Subject: NAC's Responses to NRC's Request for Additional Information (NAC-STC Submittal 17D)

Docket No. 71-9235

**FOR REVIEW OF THE CERTIFICATE OF COMPLIANCE NO. 9235, STC**  
**TRANSPORTATION PACKAGE**

Figure 2-28: Seal Life at Temperature

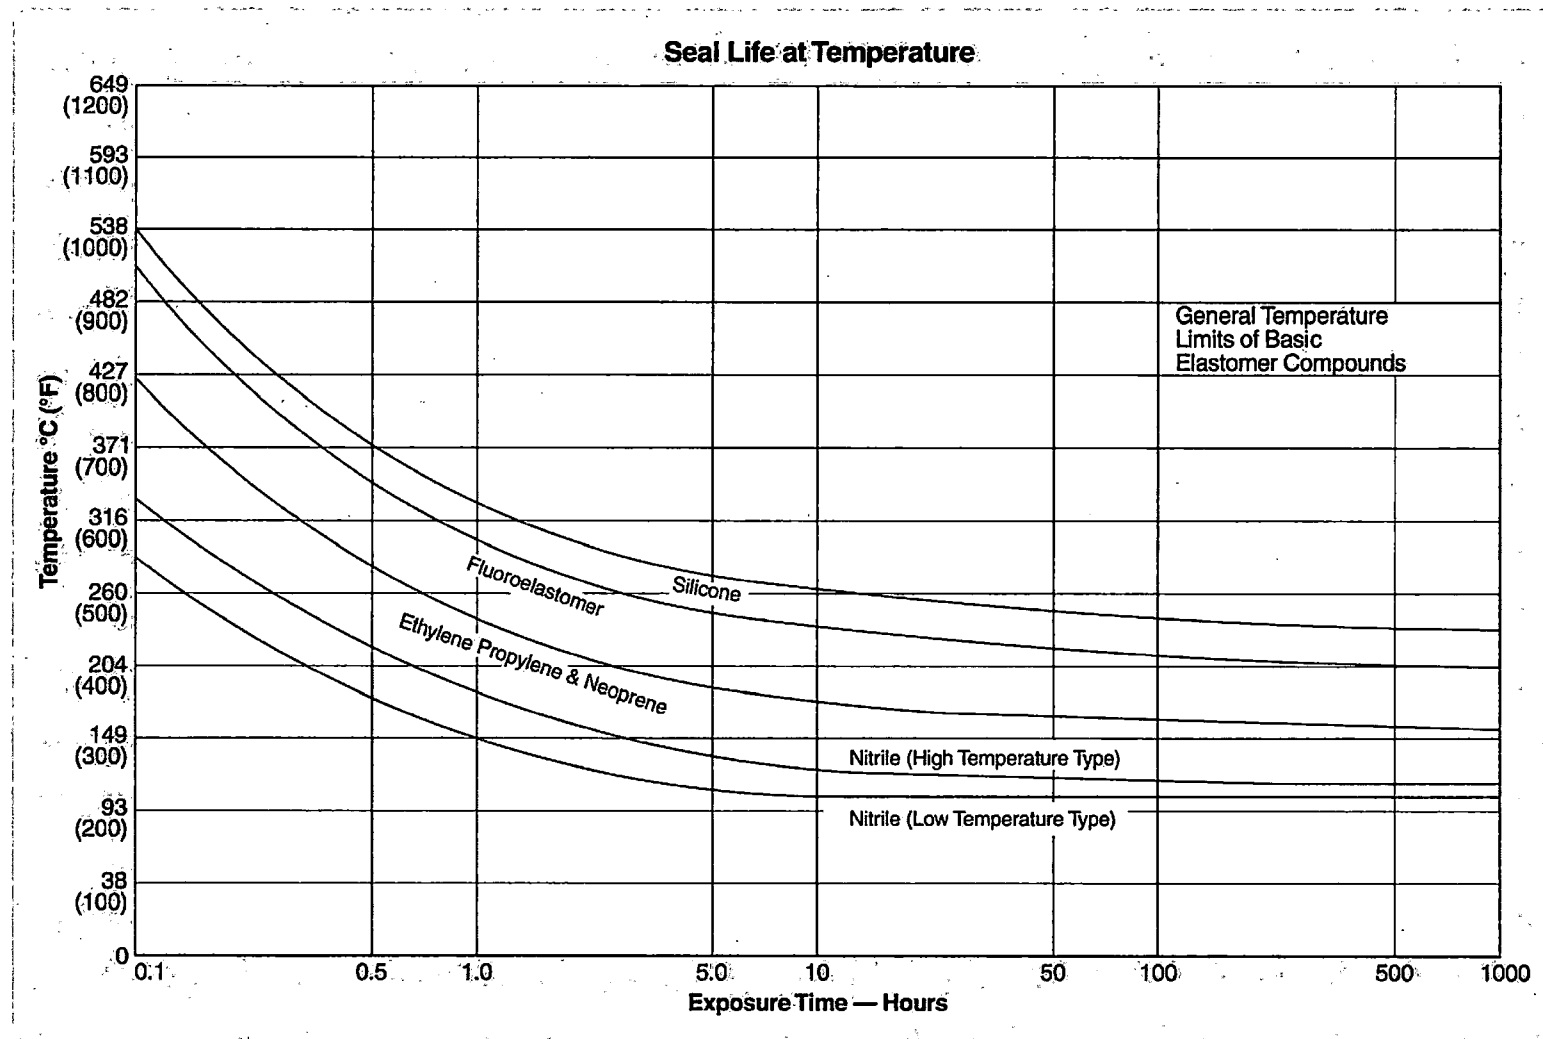
- 2.1 Justify the acceptance criteria (specification limits) assumed for the high-temperature properties of the elastomeric inner lid O-ring during the fire transient condition.

The applicant provided laboratory test data for the high-temperature properties of the O-ring during the fire transient condition, per the requirement in Title 10 of the *Code of Federal Regulations* (10 CFR) 71.73(c)(4) (Figure R-3, Calculation 423-3000, Revision 5). The data was acquired at a higher temperature than the actual maximum temperature that would be reached by the inner lid O-ring during the hypothetical fire condition. The laboratory test report defines an acceptance criteria (specification limits) for allowable changes to the O-ring properties; however, the application does not define the adequacy of these specification limits per the assumptions in the design-basis containment and structural analyses or models. The test results should demonstrate adequate margin of safety for the assumed specification limits.

NAC has provided the vendor's laboratory test report for high temperature properties measured, i.e. "spec limits", for those same physical properties which validate the material's performance for the recommended temperature range of -40°F to 400°F. Specification Limits for the Dry Heat Resistance test were all met. As NAC's application is only 418°F for 1.5 hours, the test results indicate the material exposed to a higher temperature for a significantly longer period will maintain its performance characteristics. Further, NAC is providing the vendor's "Seal Life at Temperature" graph, Figure 2-28, from the Parker O-ring Handbook (ORD-5700), which indicates the VM835 Fluoroelastomer has a seal life of almost 100 hours at 418°F. See the following page for a copy of this figure.
